Access Compliance Report Public Rights-of-Way (Curb Ramps)

Intersection ID: 10772 Main Street: E_36TH_ST Cross Street: THE_PLAZA Location: S

ADA ID: 3F98A1BC4DDD Ramp Type: PerpDiag Initial Pass/Fail: Fail Overall Compliance: No Severity Score: 13.75

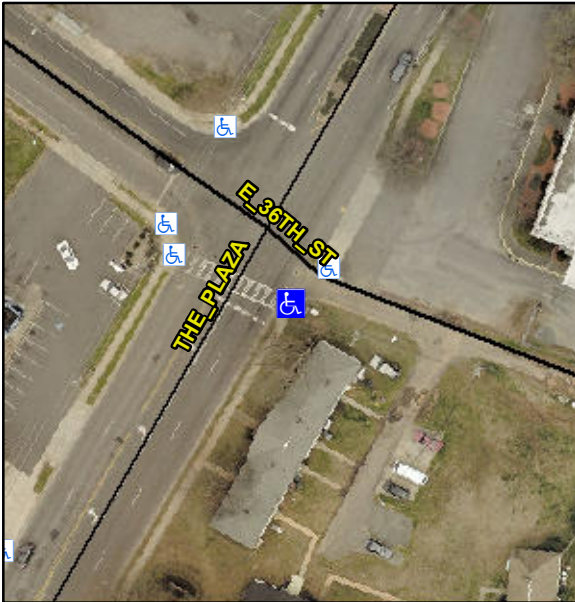
Not Found, R304.2.2, R304.5.3

Compliance	Description	Data	Compliance	Description	Data
N/A	Ramp Length (in)	59.5	No	Ramp Slope (%)	8.8
Yes	Ramp Width (in)	58.0	No	Ramp XSlope (%)	3.1
N/A	Flare Type LT	N/A	N/A	Flare Type RT	N/A
N/A	Flare Slope LT (%)	N/A	N/A	Flare Slope RT (%)	N/A
N/A	Flare Traversable LT?	N/A	N/A	Flare Traversable RT?	N/A
N/A	Landing Length (in)	N/A	N/A	DWS Provided?	N/A
N/A	Landing Width (in)	N/A	N/A	DWS Contrast?	N/A
N/A	Landing Slope (%)	N/A	N/A	DWS Length (in)	N/A
N/A	Landing X Slope (%)	N/A	N/A	DWS Full Width?	N/A
N/A	Landing Curb? (Y/N)	N/A	N/A	DWS Offset (in)	N/A
N/A	Shared Landing?	N/A			
N/A	Gutter Ponding?	N/A	N/A	Gutter Slope (%)	N/A
N/A	Gutter Lip Ht (in)	N/A	N/A	Gutter X Slope (%)	N/A
N/A	Painted X Walk1?	No	N/A	Painted X Walk2?	Yes
	X Walk 1 Direction	To NE		X Walk 2 Direction	To NW
N/A	X Walk 1 Width (in)	N/A	N/A	X Walk 2 Width (in)	95.5
	X Walk 1 Slope (%)	2.0		X Walk 2 Slope (%)	0.8
	X Walk 1 X Slope (%)	0.8		X Walk 2 X Slope (%)	3.8

Remove & Replace Curb Ramp With Two New Directional Ramps or Equivalent.
